STAFF RECOMMENDATION
1809 Sweetbriar Avenue
May 16, 2012

Application: Infill and Accessory structure
District: Belmont-Hillsboro Neighborhood Conservation Zoning Overlay
Council District: 18
Map and Parcel Number: 11704006000
Applicant: Brent Craig, Rigid Development
Project Lead: Sean Alexander, sean.alexander@nashville.gov

1809 Sweetbriar - Left Elevation - 1/4" = 1'-0"

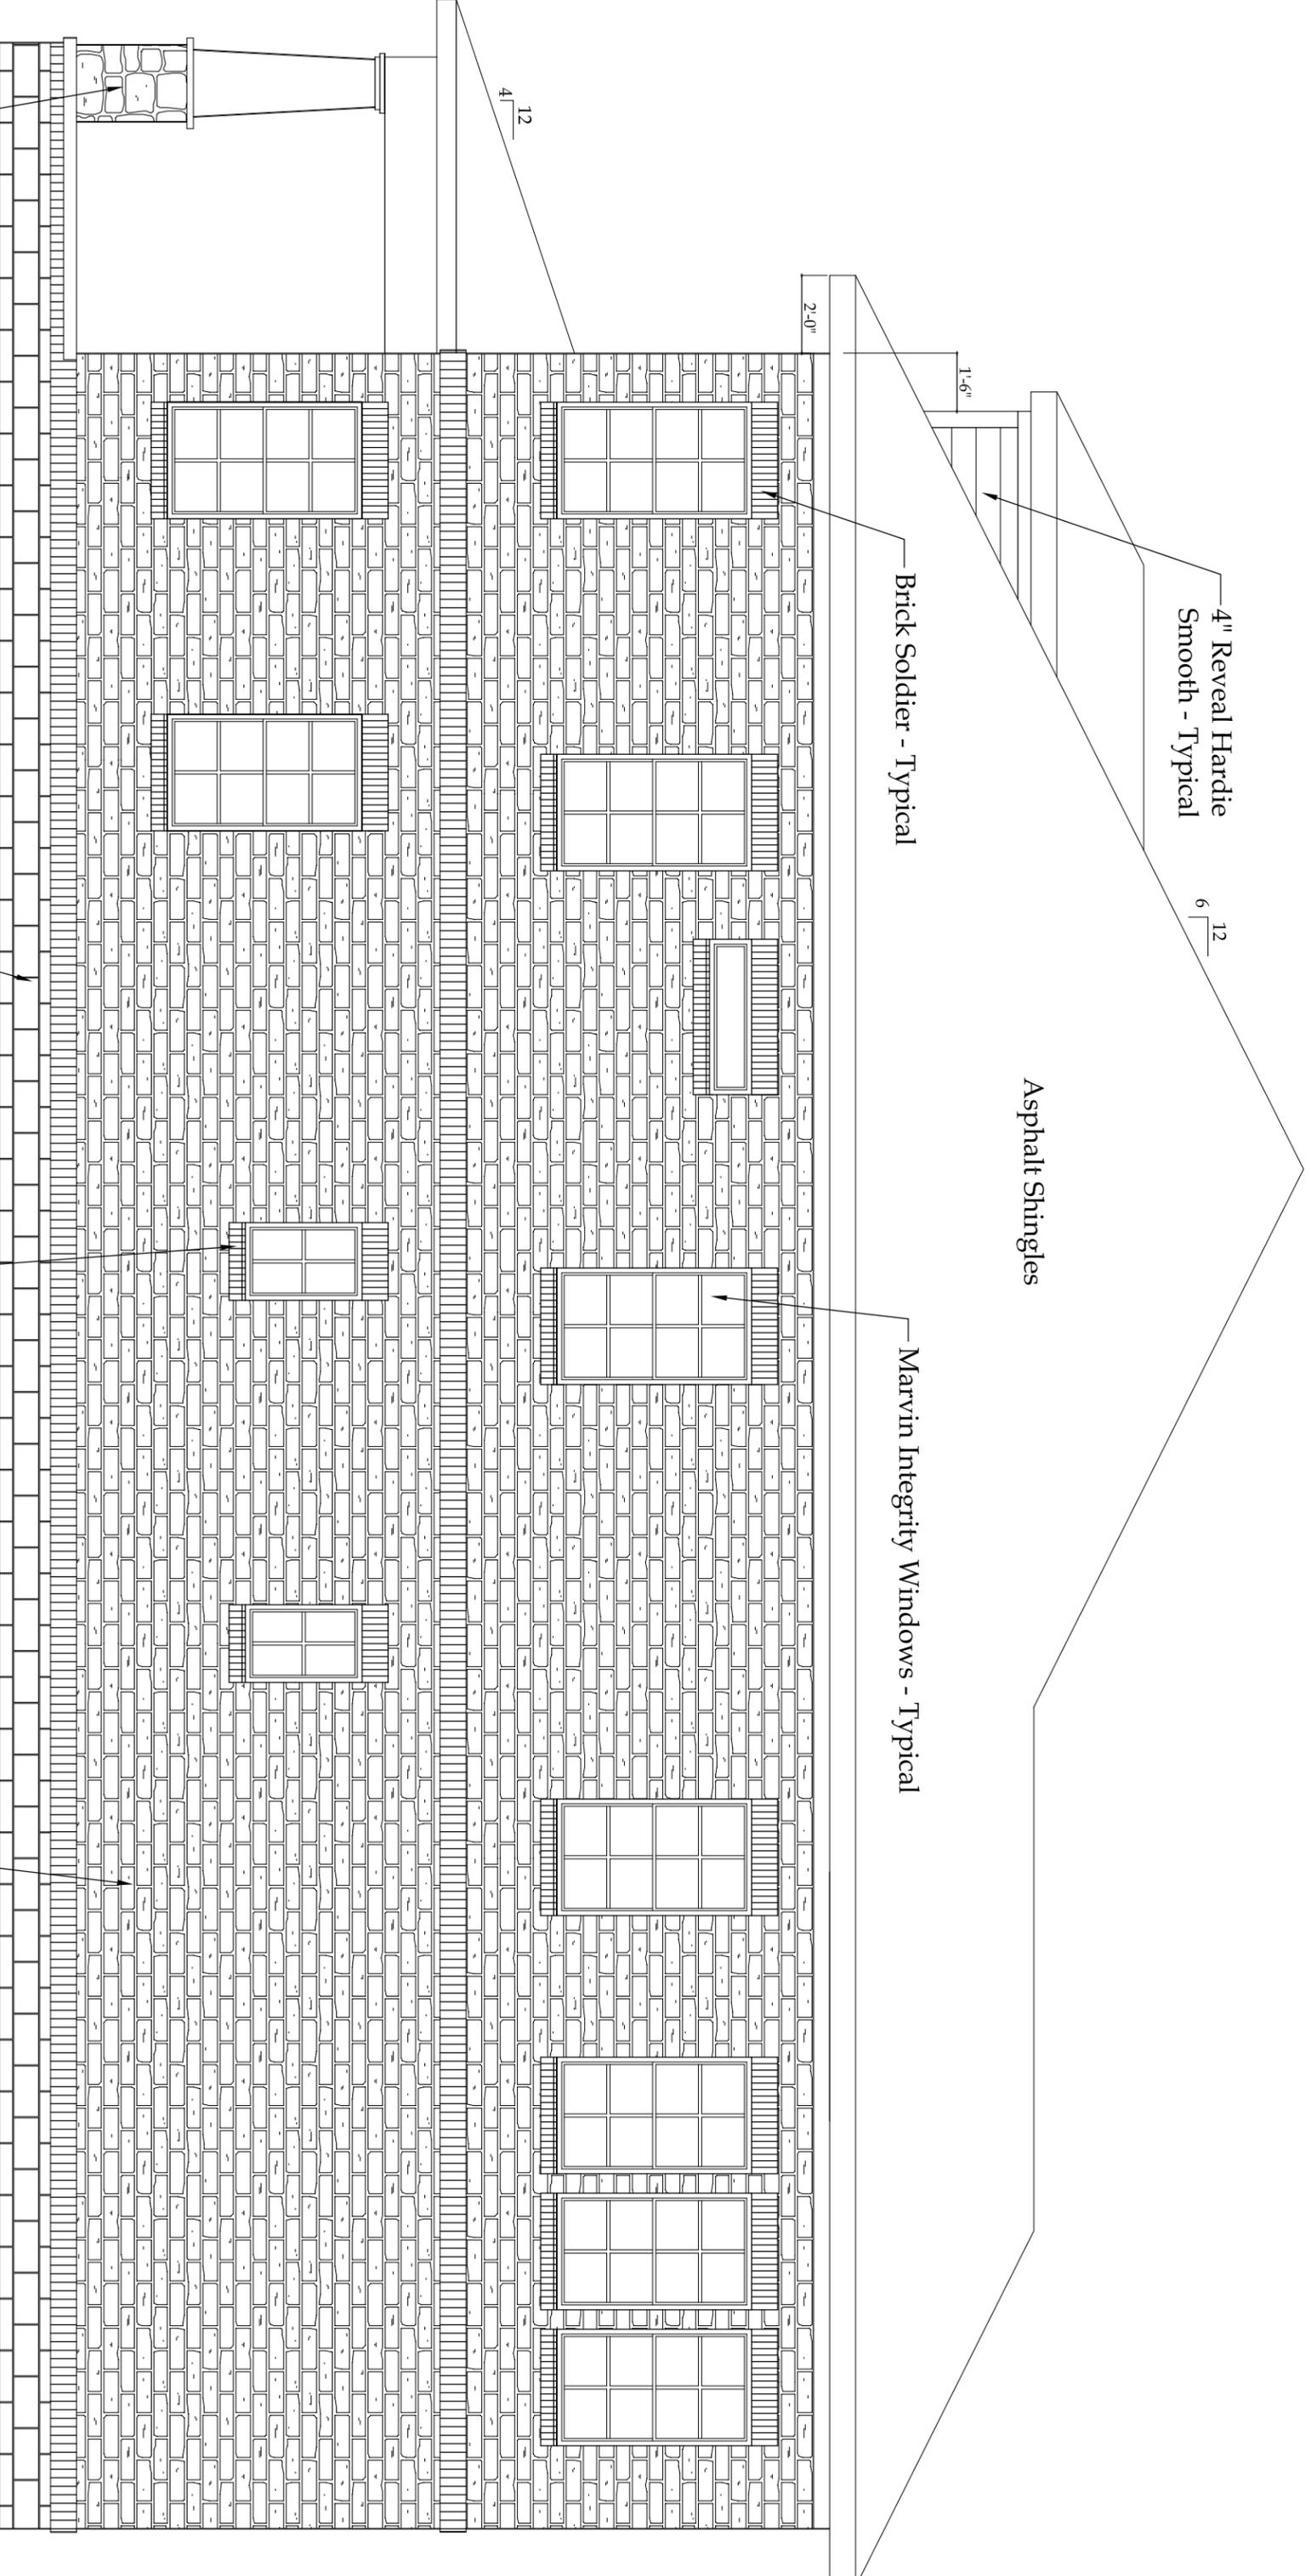
Although the elevations show the lot as being flat, there is actually a considerable drop from right to left. On historic houses where the lot slopes side-to-side, typically the foundation at the highest corner will be one course of stone or block and get taller along the foundation as the grade drops. Staff is concerned that without accurate elevations, the actual height of the structure and the foundation itself cannot be determined.

- Elevations show building on flat ground but there is a significant change in grade
- The double windows cannot be constructed as shown.
- The site and floor plans indicate that there will be a covered deck at the rear of the structure, but it is not drawn on the elevations.
- Not all materials are noted.
